# Access Compliance Report

## Public Rights-of-Way

### (Curb Ramps)

Intersection ID: 17321	Main Street: QUEENS_RD_EAST	Cross Street: QUEENS_RD_WEST	Location: NW
ADA ID: A98A4BF91D47	Ramp Type: Perp	Initial Pass/Fail: Fail	Overall Compliance: No
Severity Score: 13.75			
Codes/Mitigation Info/Possible Solution		Field Measurements/Component Compliance

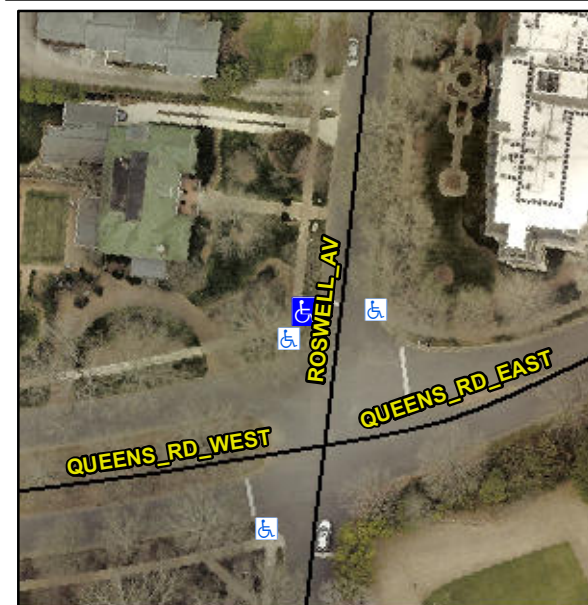
**Not Found, R304.2.2, R304.5.3**

Compliance	Description	Data	Compliance	Description	Data
N/A	Ramp Length (in)	105.0	No	Ramp Slope (%)	10.4
Yes	Ramp Width (in)	60.0	No	Ramp XSlope (%)	2.8
N/A	Flare Type LT	N/A	N/A	Flare Type RT	N/A
N/A	Flare Slope LT (%)	N/A	N/A	Flare Slope RT (%)	N/A
N/A	Flare Traversable LT?	N/A	N/A	Flare Traversable RT?	N/A
N/A	Landing Length (in)	N/A	N/A	DWS Provided?	N/A
N/A	Landing Width (in)	N/A	N/A	DWS Contrast?	N/A
N/A	Landing Slope (%)	N/A	N/A	DWS Length (in)	N/A
N/A	Landing X Slope (%)	N/A	N/A	DWS Full Width?	N/A
N/A	Landing Curb? (Y/N)	N/A	N/A	DWS Offset (in)	N/A
N/A	Shared Landing?	N/A			
N/A	Gutter Ponding?	N/A	N/A	Gutter Slope (%)	N/A
N/A	Gutter Lip Ht (in)	N/A	N/A	Gutter X Slope (%)	N/A
N/A	Painted X Walk1?	No	N/A	Painted X Walk2?	N/A
	X Walk 1 Direction	To E		X Walk 2 Direction	N/A
N/A	X Walk 1 Width (in)	N/A	N/A	X Walk 2 Width (in)	N/A
	X Walk 1 Slope (%)	4.2		X Walk 2 Slope (%)	N/A
	X Walk 1 X Slope (%)	0.5		X Walk 2 X Slope (%)	N/A

**Remove & Replace Entire Ramp.**
